City of Mississauga Department Comments

Date Finalized: 2022-07-20 File(s): A344.22
Ward: 1

Property Address: 233 Indian Valley Trail

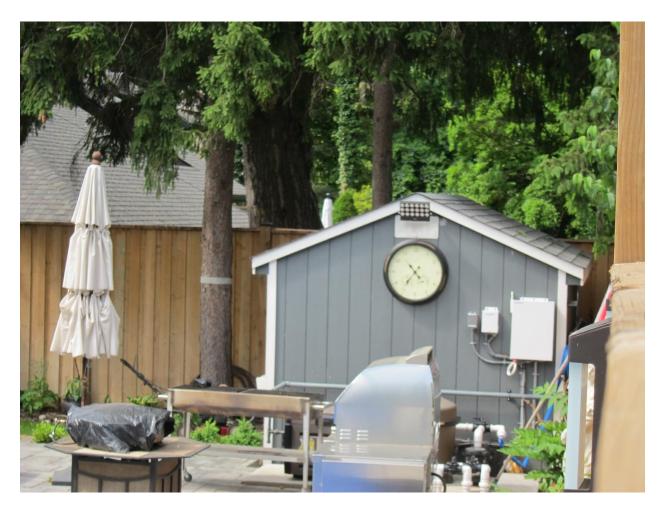
Enclosed you will find photos of the existing 2 sheds on the property. We ask that the smaller shed on the west side of the lot be equipped with an eaves trough and downspout directed in such a manor that it does not impact the adjacent properties.
